**JOINT REGIONAL PLANNING PANEL
(Sydney Region East)**

JRPP No	2014SYE003
DA Number	323/13
Local Government Area	NORTH SYDNEY COUNCIL
Proposed Development	NEW MIXED USE BUILDING
Street Address	7-19 ALBANY STREET, ST LEONARDS
Applicant	P. D. MAYOH ARCHITECTS
Number of Submissions	Original Notification – 2; Amended plans - 6
Recommendation	Approval with Conditions
Report by	Lara Huckstepp, Executive Planner

Assessment Report and Recommendation

No.34 Oxley Street – Northern facade

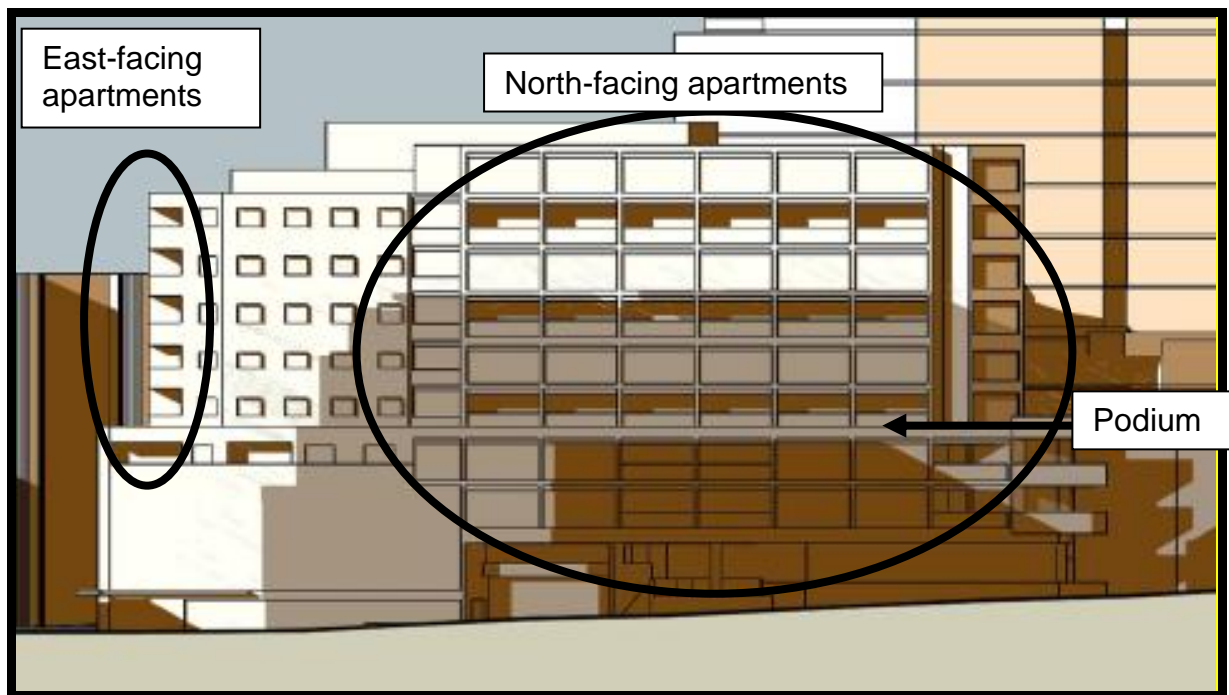
The proposed development will result in a loss of solar access for a number of apartments within No.34 Oxley Street. There are 29 apartments having their primary outlook from this property on the northern elevation across the subject site. A further 6 apartments have their outlook to the east, however have a number of kitchen and bedroom windows along this northern elevation, as can be seen below:

East Facing Apartments – The upper three levels of apartments will continue to receive at least 5 hours of sunlight within midwinter and will comply with Council's controls.

The lower three apartments will experience overshadowing. North-facing kitchen windows will receive sunlight between 9am and 10am, however will be overshadowing after this time. Bedroom windows will also be overshadowed during the midwinter period. However, these apartments each have east-facing balconies which all remain unaffected and will receive the required minimum of 3 hours within the morning periods.

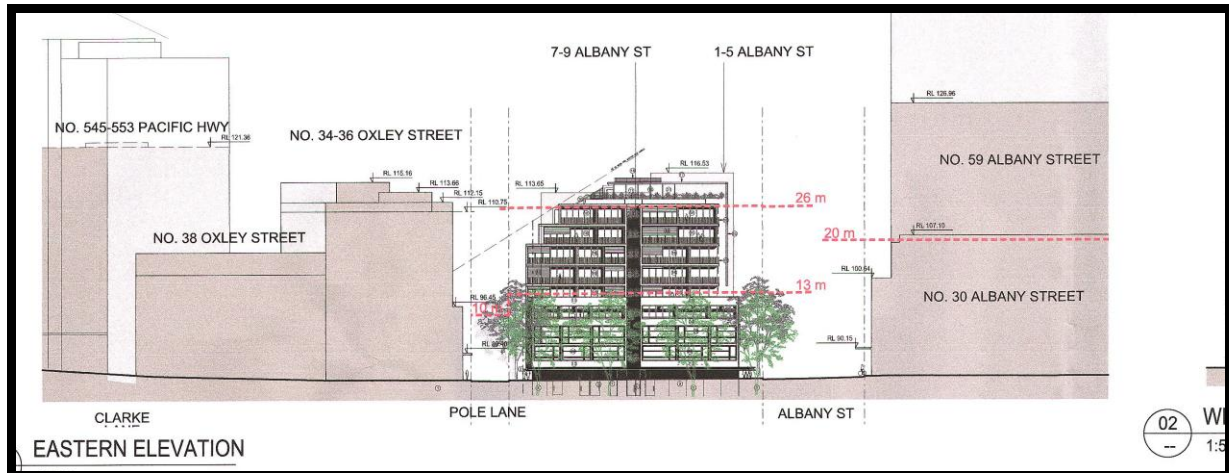
A total of 11 single level apartments are located below the podium over Levels 1 and 2. All of these apartments will be overshadowed such that they receive no sunlight between 9am - 3pm during the midwinter solstice.

The proposed development results in a total of 17 out of the 29 apartments being non-compliant with the minimum 2 hours solar access requirement. The building design however complies with DCP Laneway setbacks, SEPP 65 separation requirements and building

Subject roof terraces at No.1-5 Albany Street

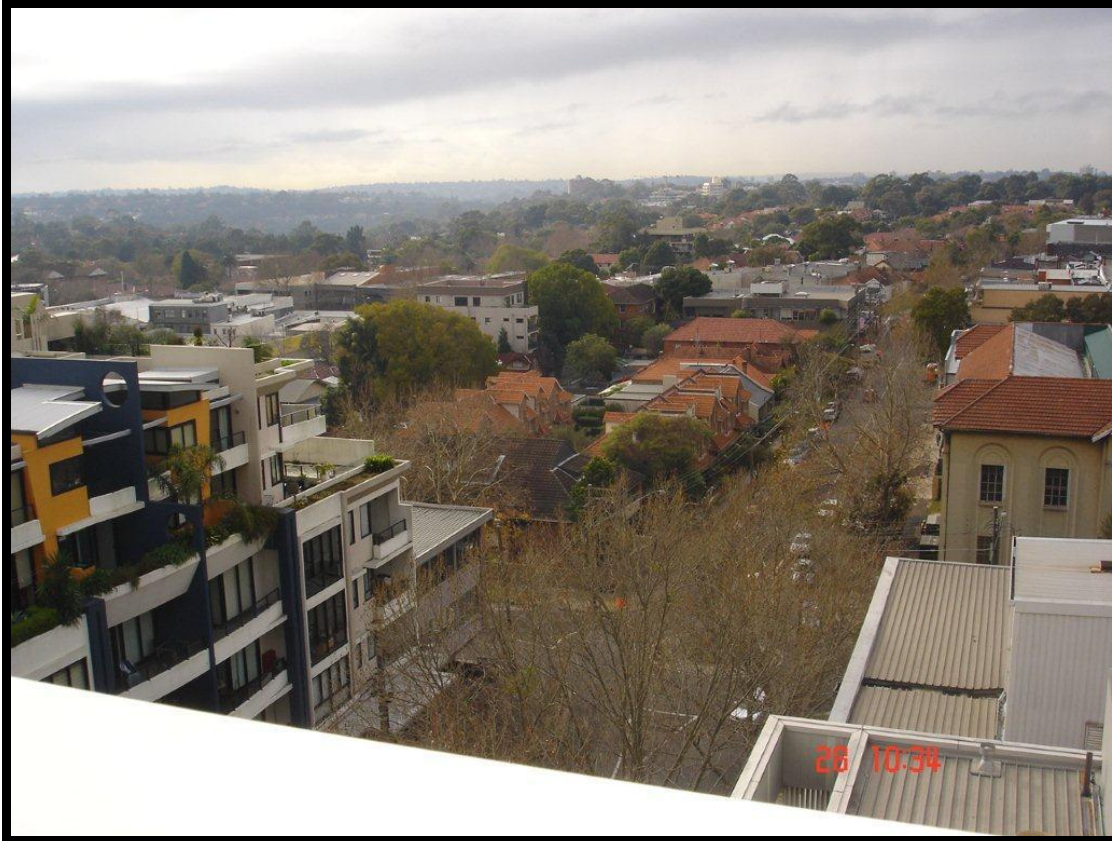
Notwithstanding the above, the three northern roof terraces also enjoy a north-easterly aspect. To ensure this is retained to the lower roof terrace, as part of the amended plans the applicant was requested to lower the height of the western parapet where it adjoins No.1-5 Albany Street to ensure north-eastern views are maintained.

With regards to views from the southern terrace and facade, it is noted that the proposed building where it adjoins this terrace proposes a 6m setback from the laneway at this level, wherein the existing terrace provides only 3m. As such, a view corridor, although much reduced, would be retained to the south / east until it is interrupted by the existing No.34 Oxley Street. A view of the terraces can be seen below:

Proposed northern elevation

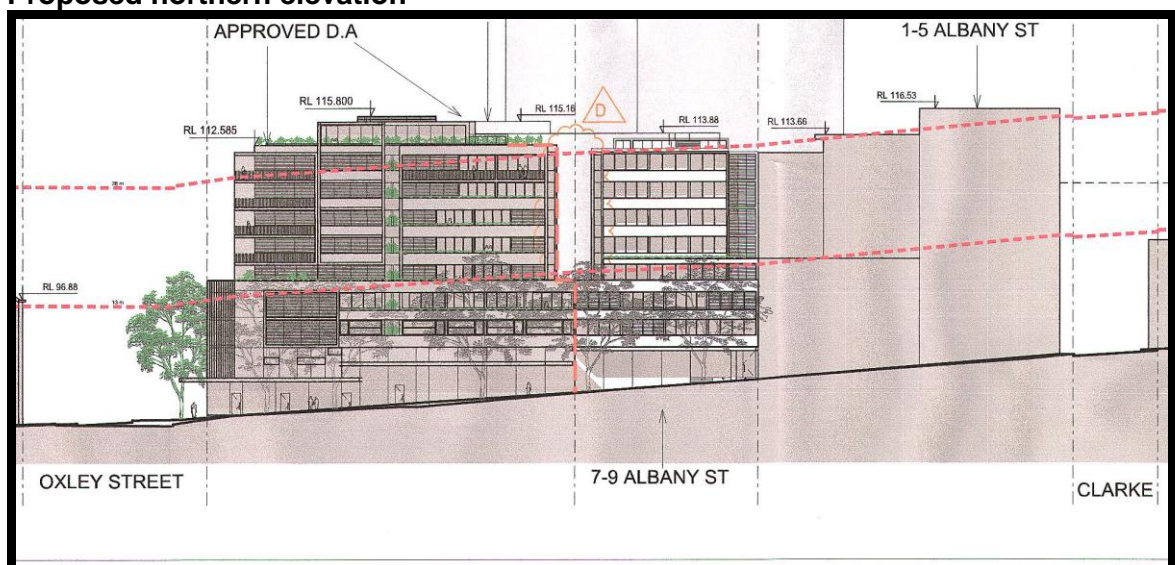
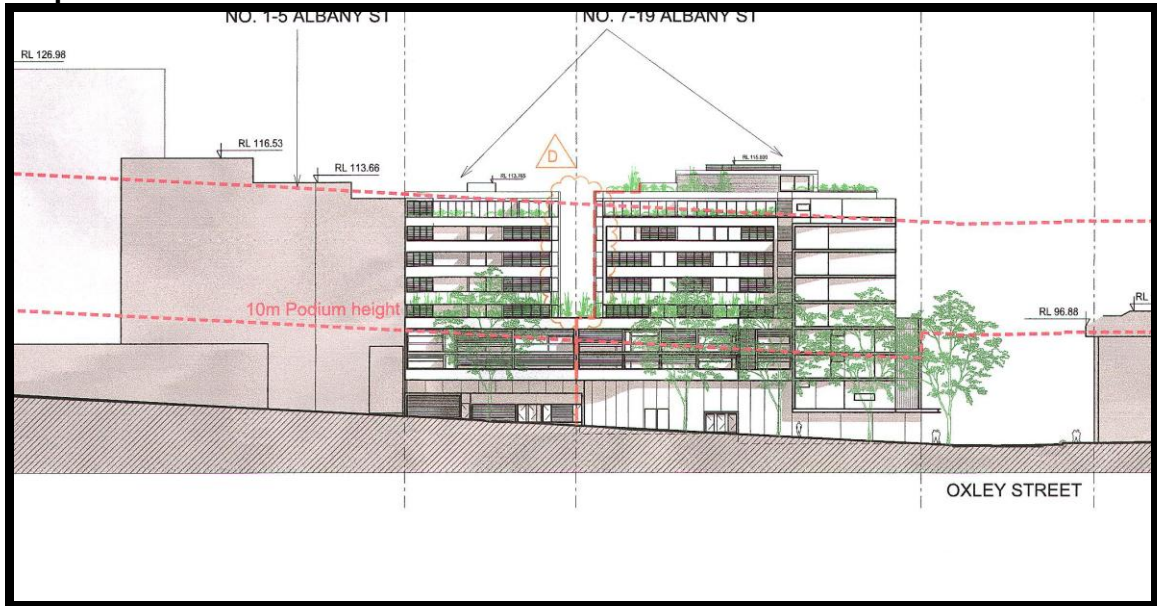
Clause 4.3 NSLEP 2013 sets a maximum building height on the site of 26m. The proposed development results in an overall building height of 31.7m. It is noted that the height of the residential level (Level 8) has a maximum height ranging between 26.5m – 28.5m. The additional breach occurs from the roof plant and community facilities. The applicant has submitted a request for an exemption from this standard pursuant to Clause 4.6 LEP2013. The proposal is considered against the objectives of the control as follows:

The roof top communal structures are located above the height limit however in this instance are considered to have merit for the following reasons:-

- There are no material overshadowing, privacy or view impacts caused by these structures.
- The site is a substantial size and can accommodate generous setbacks from the boundary to these structures.
- The structures have been set to the north-east corner of the site wherein the least impact to surrounding dwellings would occur.
- The location of community facilities on the roof is a common feature of the locality and provides a communal benefit to the building's occupants. A rooftop terrace is located in the north-east corner of No.34 Oxley Street which has a height that is non-complying with the 26m control.
